Access Compliance Report

Public Rights-of-Way

(Curb Ramps)

Intersection ID: 42798	Main Street: CRIMSON_SARGENT_DR	Cross Street: LADY_CLARE_DR	Location: SE
ADA ID: FAB873E0D2CE	Ramp Type: PerpDiag	Initial Pass/Fail: Fail	Overall Compliance: No
Severity Score: 21.25			
Codes/Mitigation Info/Possible Solution		Field Measurements/Component Compliance

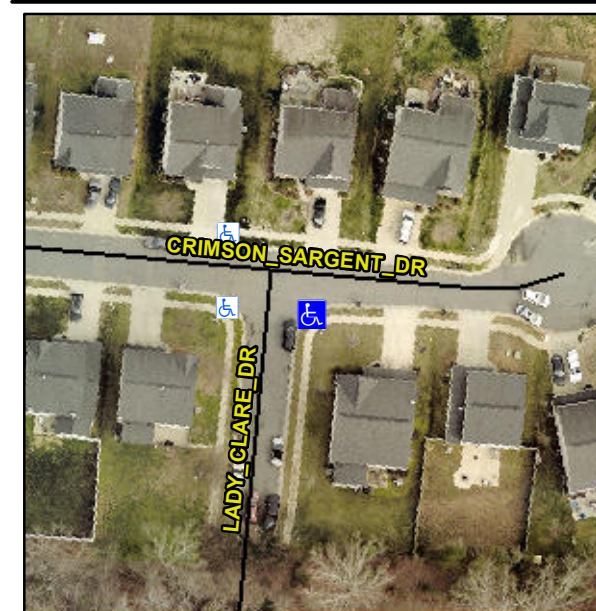
Not Found, R304.5.1, R304.2.2

Compliance	Description	Data	Compliance	Description	Data
N/A	Ramp Length (in)	48.5	No	Ramp Slope (%)	11.7
No	Ramp Width (in)	46.5	Yes	Ramp XSlope (%)	1.8
N/A	Flare Type LT	N/A	N/A	Flare Type RT	N/A
N/A	Flare Slope LT (%)	N/A	N/A	Flare Slope RT (%)	N/A
N/A	Flare Traversable LT?	N/A	N/A	Flare Traversable RT?	N/A
N/A	Landing Length (in)	N/A	N/A	DWS Provided?	N/A
N/A	Landing Width (in)	N/A	N/A	DWS Contrast?	N/A
N/A	Landing Slope (%)	N/A	N/A	DWS Length (in)	N/A
N/A	Landing X Slope (%)	N/A	N/A	DWS Full Width?	N/A
N/A	Landing Curb? (Y/N)	N/A	N/A	DWS Offset (in)	N/A
N/A	Shared Landing?	N/A			
N/A	Gutter Ponding?	N/A	N/A	Gutter Slope (%)	N/A
N/A	Gutter Lip Ht (in)	N/A	N/A	Gutter X Slope (%)	N/A
N/A	Painted X Walk1?	No	N/A	Painted X Walk2?	No
	X Walk 1 Direction	To N		X Walk 2 Direction	To W
N/A	X Walk 1 Width (in)	N/A	N/A	X Walk 2 Width (in)	N/A
	X Walk 1 Slope (%)	0.2		X Walk 2 Slope (%)	2.5
	X Walk 1 X Slope (%)	0.0		X Walk 2 X Slope (%)	0.8

Remove & Replace Curb Ramp With Two New Directional Ramps or Equivalent.
